DECISION OF THE HISTORIC LANDMARKS COMMISSION

HISTORIC DESIGN REVIEW CASE NO.: HIS19-05

SUMMARY: A proposal to reopen windows on the south façade of the Bligh Building (aka Pacific Building, 1926).

CASE NO. Historic Review Case No. HIS19-05

1 LEVEL 02 FLOOR PLAN HLC SUBMISSION

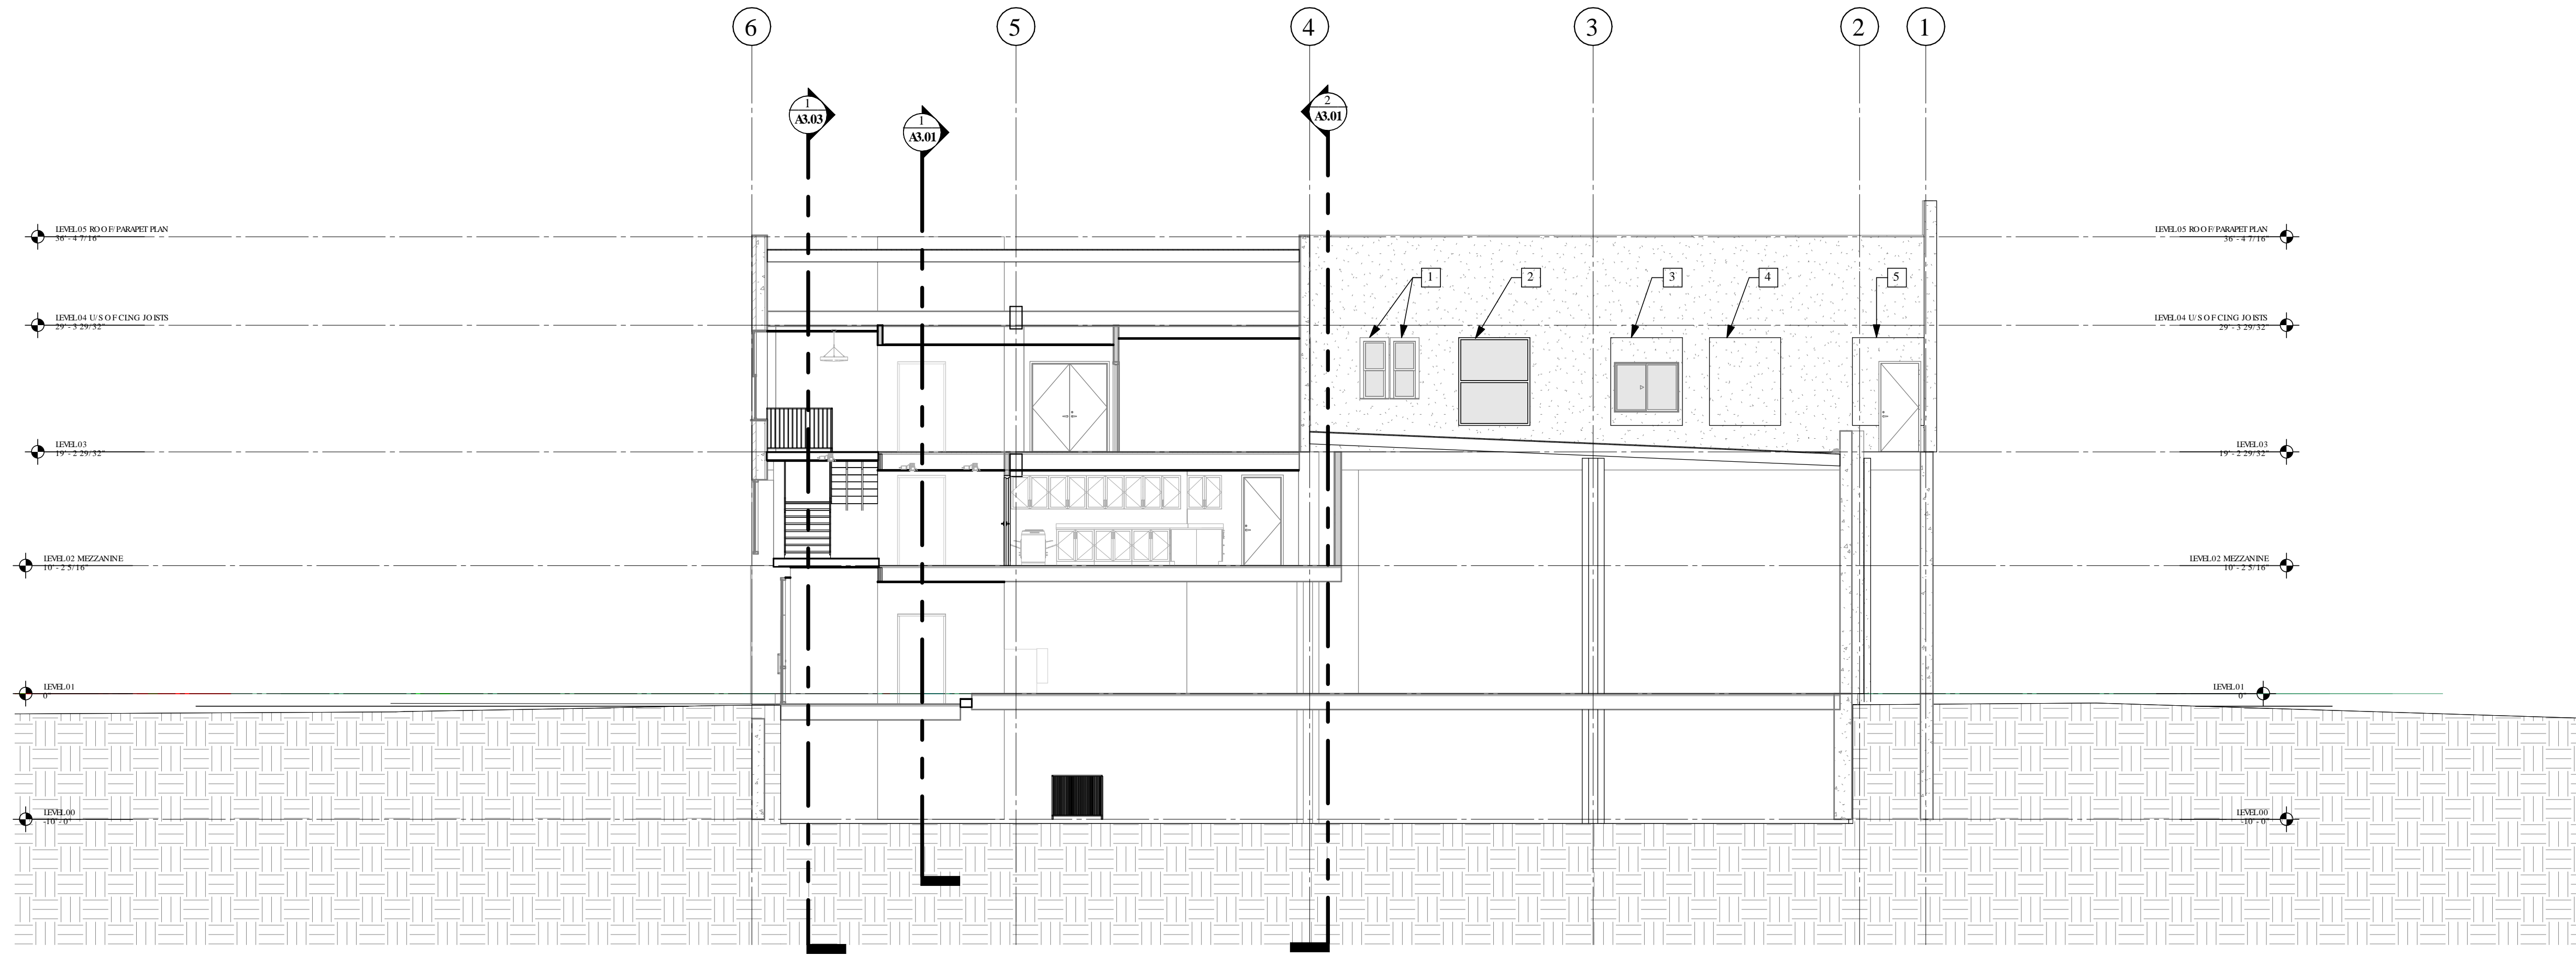
- EXISTING WINDOW OPENING THAT HAS BEEN INFILLED WITH FRAMING AND STUCCO. WINDOW TO BE RE-OPENED AND RECEIVE NEW WINDOW WITH CONFIGURATION TO LOOK SIMILAR TO ORIGINAL AND EXISTING WINDOWS. MATERIAL TO BE EITHER PAINTABLE FIBERGLASS OR ALUMINUM.

- EXISTING WINDOW OPENING THAT HAS BEEN INFILLED WITH FRAMING AND STUCCO, AND SUBSEQUENTLY PARTIALLY RE-OPENED. EXISTING WINDOW IS AN ALUMINUM OR VINYL HORIZONTAL SLIDER.

- EXISTING WINDOW OPENING THAT HAS BEEN INFILLED WITH FRAMING AND STUCCO. TO BE RE-OPENED AT A LATER DATE.
- EXISTING WINDOW OPENING THAT HAS PREVIOUSLY BEEN INFILLED WITH FRAMING AND STUCCO. SUBSEQUENTLY PARTIALLY RE-OPENED TO PROVIDE AN EXT DOOR. (NO CHANGE).

1 SECTION 3, HLC SUBMISSION
0" 2" 4" 8" 16" 24" 1/8" = 1'-0"

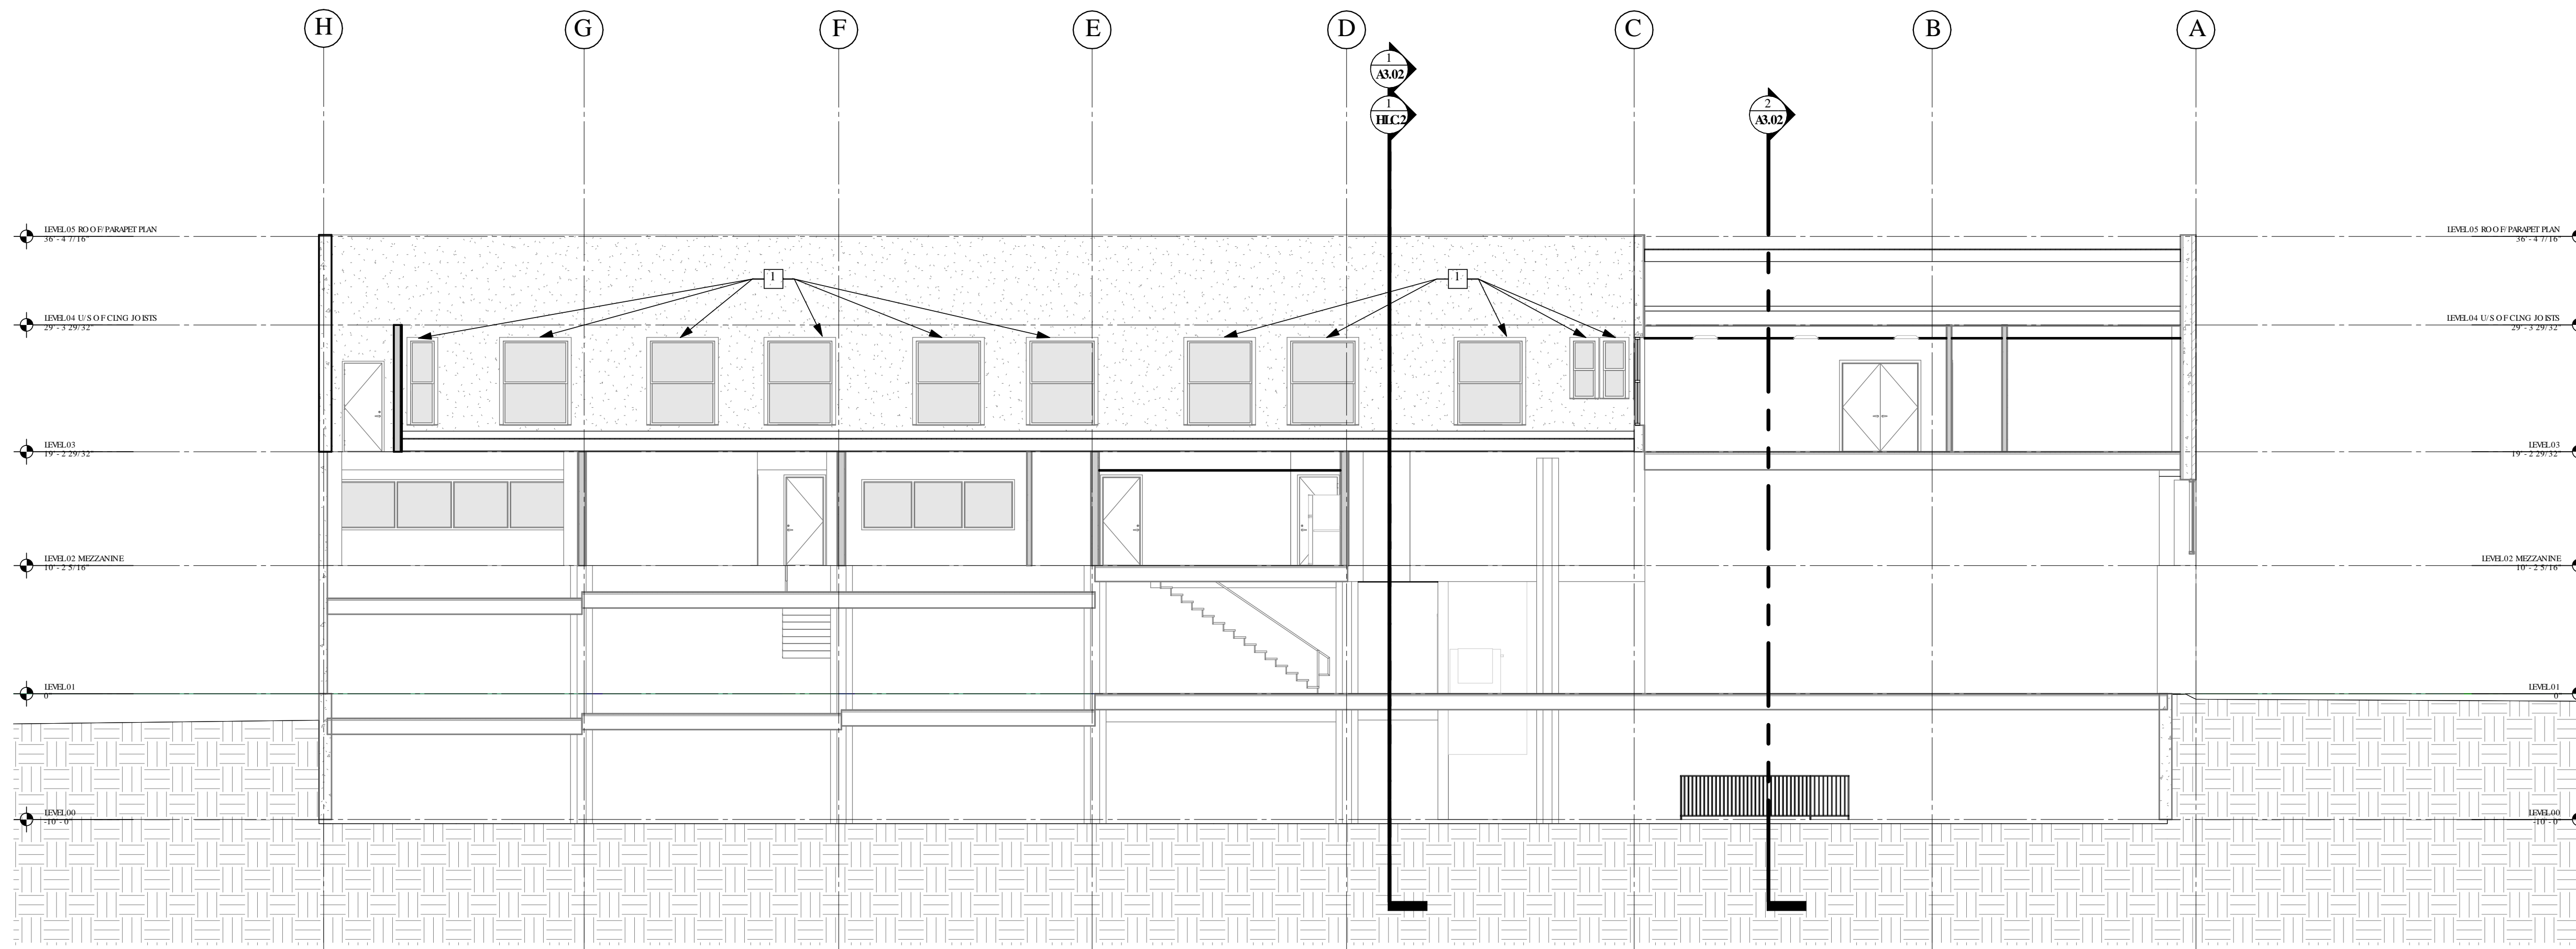
- 2 EXISTING WINDOW OPENING THAT HAS BEEN INFILLED WITH FRAMING AND STUCCO. WINDOW TO BE RE-OPENED AND RECEIVE NEW WINDOW WITH CONFIGURATION TO LOOK SIMILAR TO ORIGINAL AND EXISTING WINDOWS. MATERIAL TO BE EITHER PAINTABLE FIBERGLASS OR ALUMINUM.

- 3 EXISTING WINDOW OPENING THAT HAS BEEN INFILLED WITH FRAMING AND STUCCO, AND SUBSEQUENTLY PARTIALLY RE-OPENED. REMOVE EXISTING WINDOW AND WALL CLOSURE, AND PREPARE FOR NEW WINDOW WITH CONFIGURATION TO LOOK SIMILAR TO ORIGINAL WINDOWS, SAME AS NOTE 2 ABOVE. MATERIAL TO BE EITHER PAINTABLE FIBER GLASS OR ANODIZED ALUMINUM.

- 4 EXISTING WINDOW OPENING THAT HAS BEEN INFILLED WITH FRAMING AND STUCCO. NO ACTION AT THIS TIME.
- 5 EXISTING WINDOW OPENING THAT HAS PREVIOUSLY BEEN INFILLED WITH FRAMING AND STUCCO. SUBSEQUENTLY PARTIALLY RE-OPENED TO PROVIDE AN EXIT DOOR. (NO CHANGE).
